CITY OF ALBUQUERQUE

Re: Zocalo
501 Coal Ave. SW
Traffic Circulation Layout
Engineer's 12-19-17 (K14-D112)

SHEET TITLE
TRAFFIC CIRCULATION LAYOUT

TCL

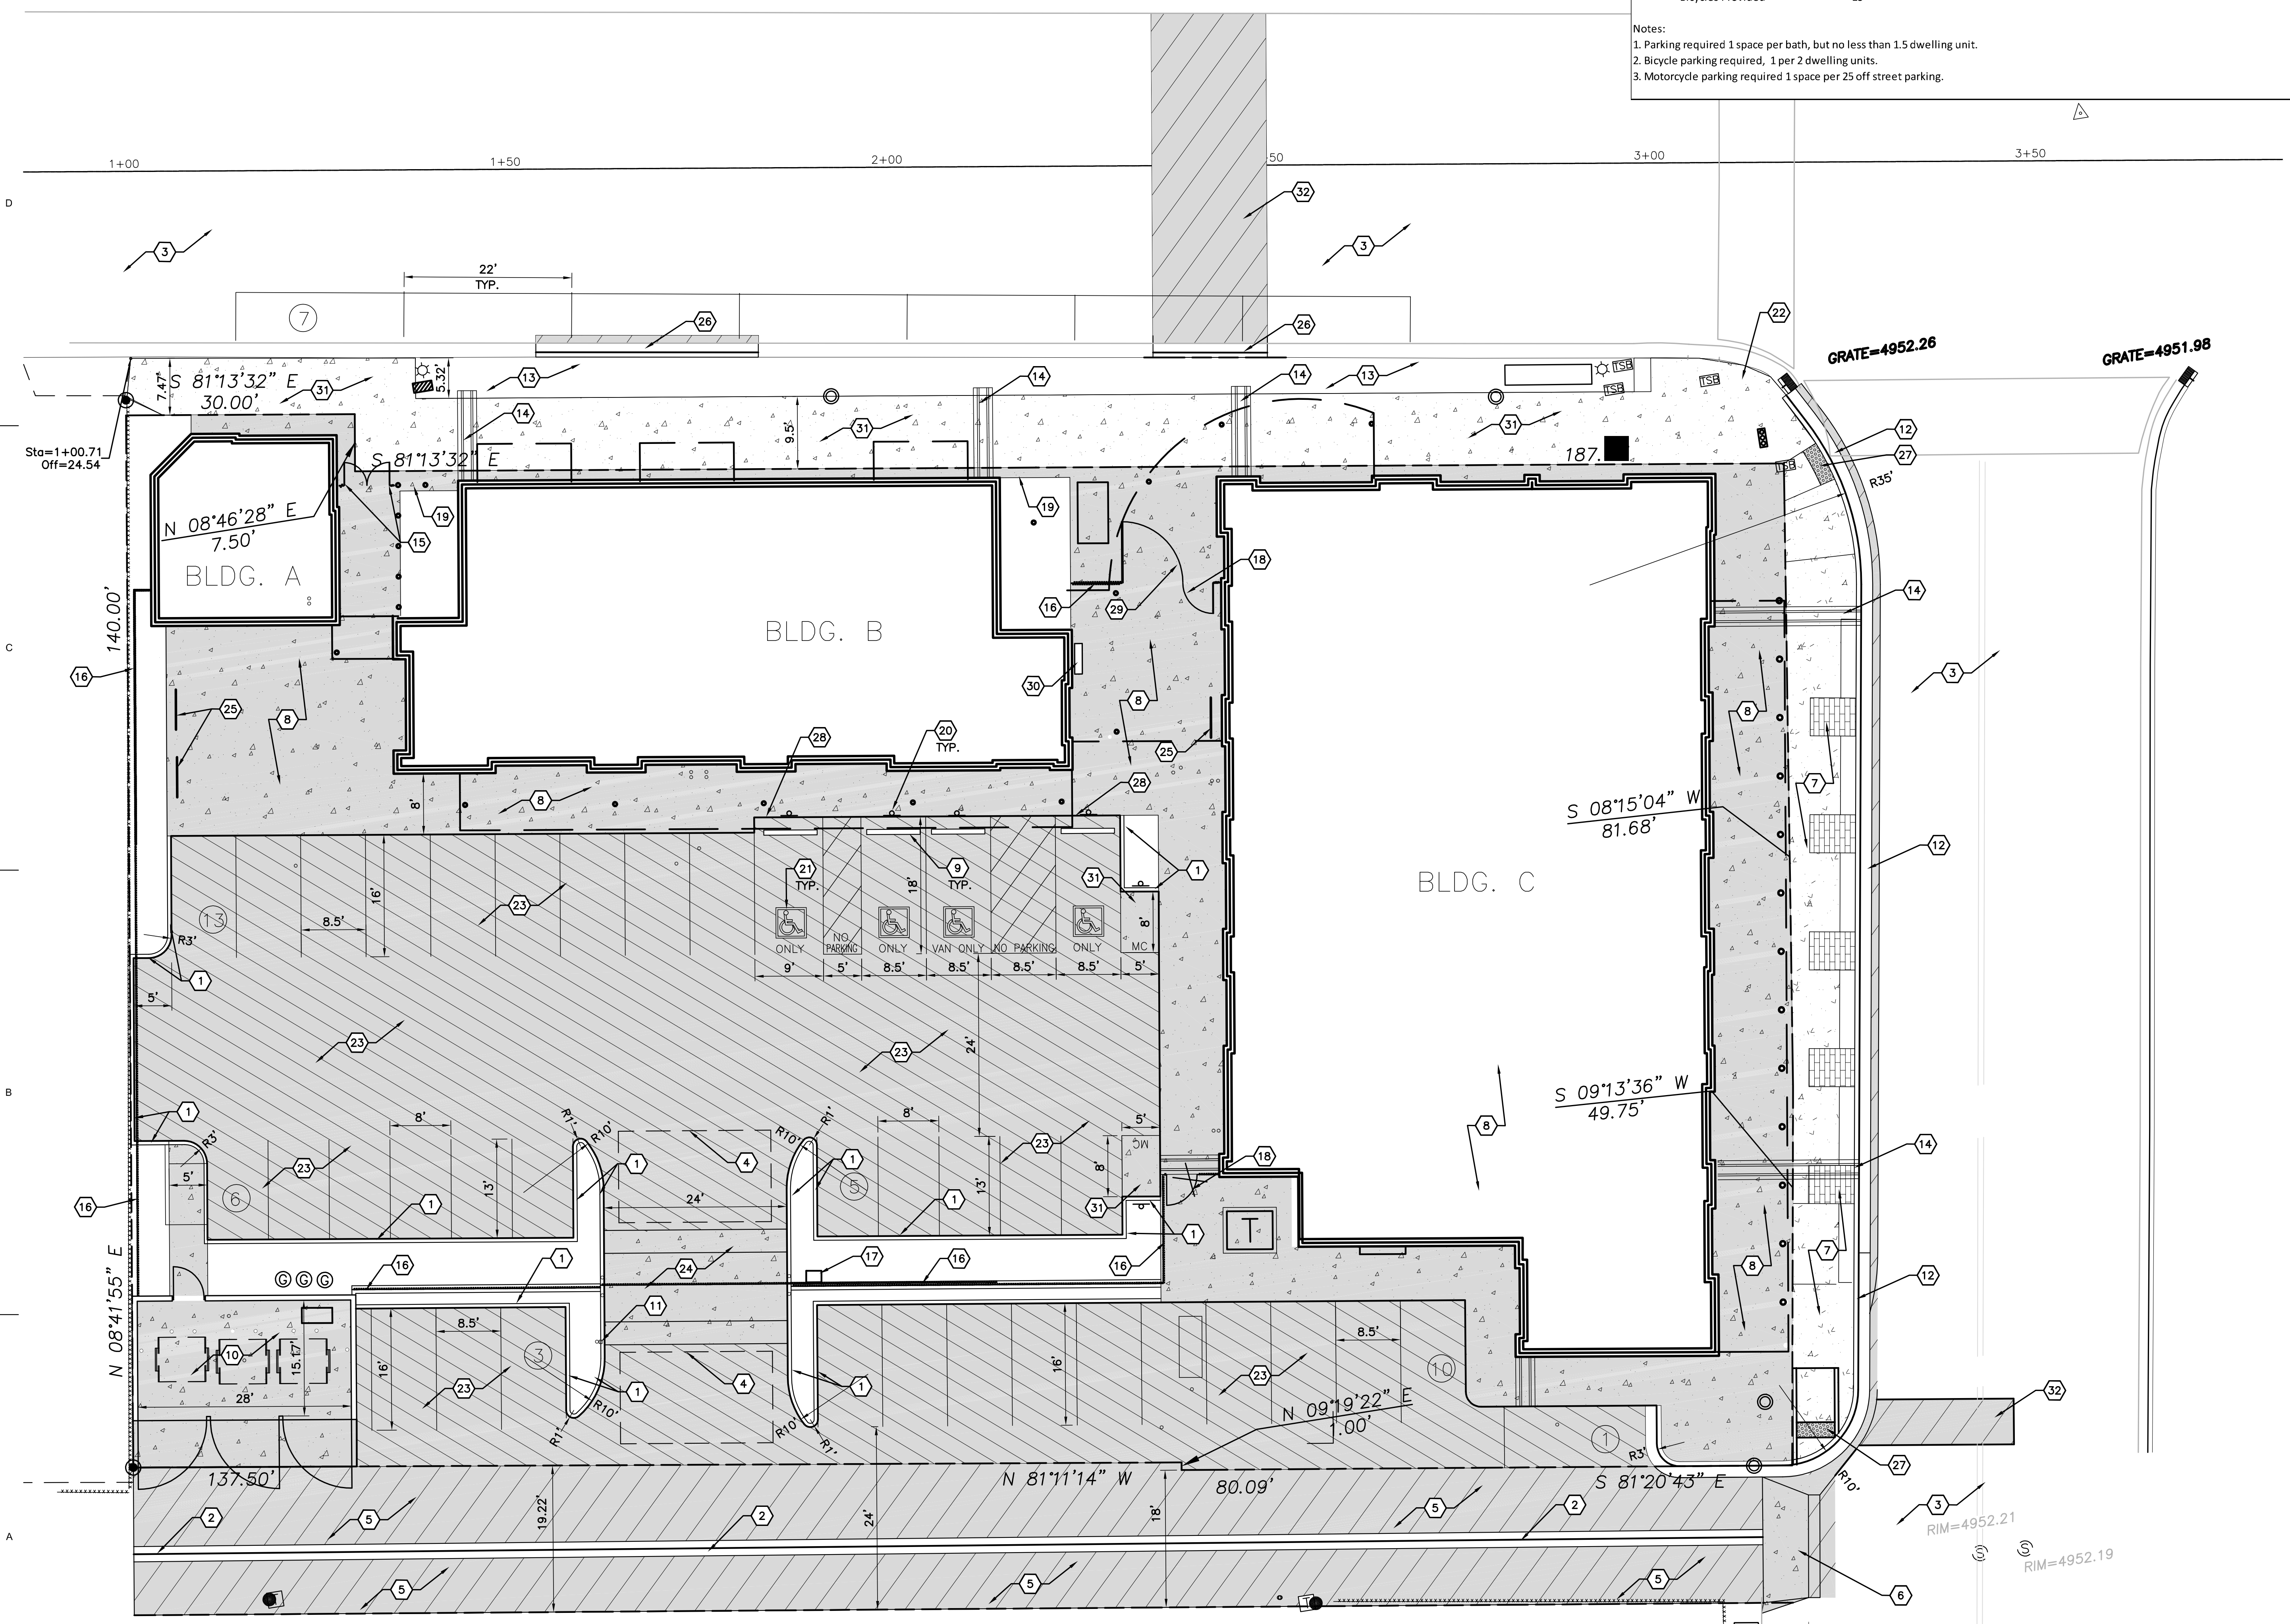
1. Motorcycle parking spaces shall be designated by its own conspicuously posted upright sign, either free-standing or wall mounted per the zoning code.
2. On-Street parking credit to fulfill zoning's parking requirement must be requested and approved by the Traffic Engineer, Racquel Michel prior to TCL approval. The application requires at least 45 working days. On-street parking credit is based on available parking along public right-of-ways fronting the property. The business will only be granted 50% credit for available street parking.
